Date: January 11, 2022
From: Ray Jones and Shoji Takahashi
To: Transportation Advisory Committee (TAC)
Subject: Request for Crosswalk Across Summer St at Newland Rd for Peirce Elementary.

1 Summer St looking west from Forest St.

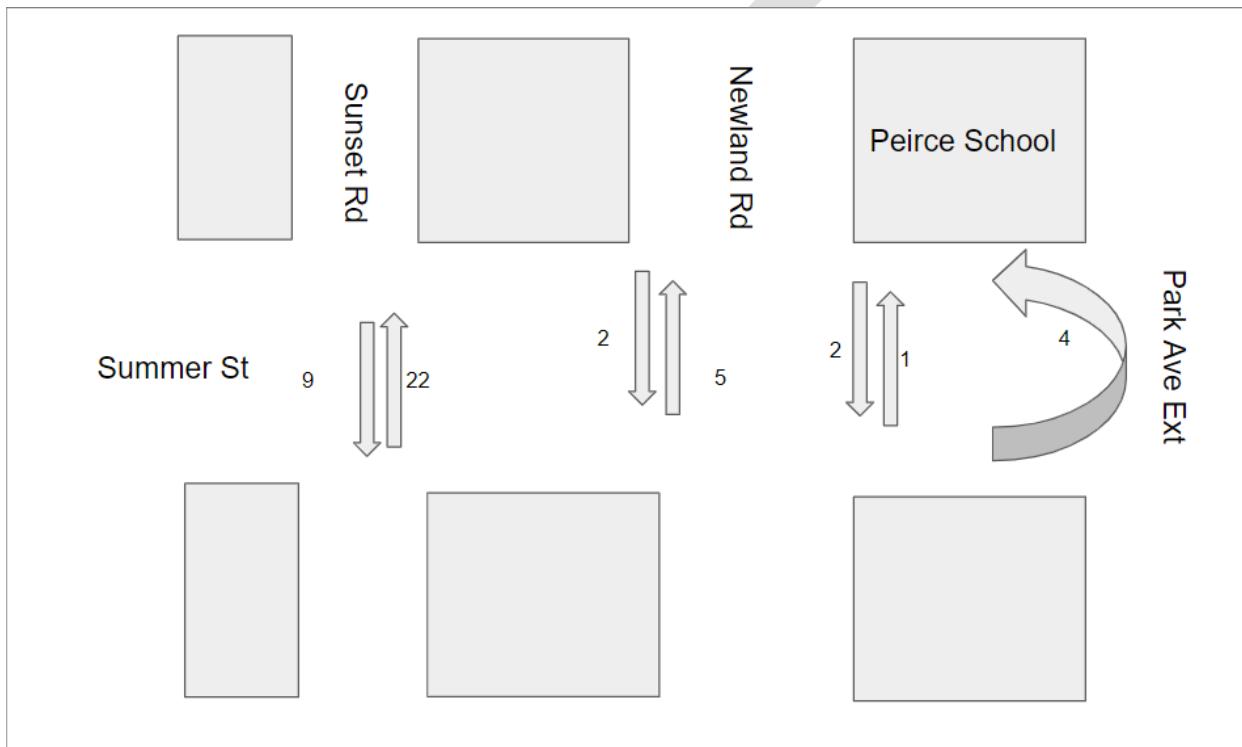
The speed limit at this location is the Town-wide 25 mph with the minimum recommended stopping sight distance of 155'. On the conservative side, if the 85th percentile speed at this location is 35 mph, the minimum recommended sight distance is 250'. Westbound drivers can see the Sunset Rd intersection at Forest St, which is a distance of more than 350'. Eastbound drivers can see the Sunset Rd intersection at a distance of more than 400'.
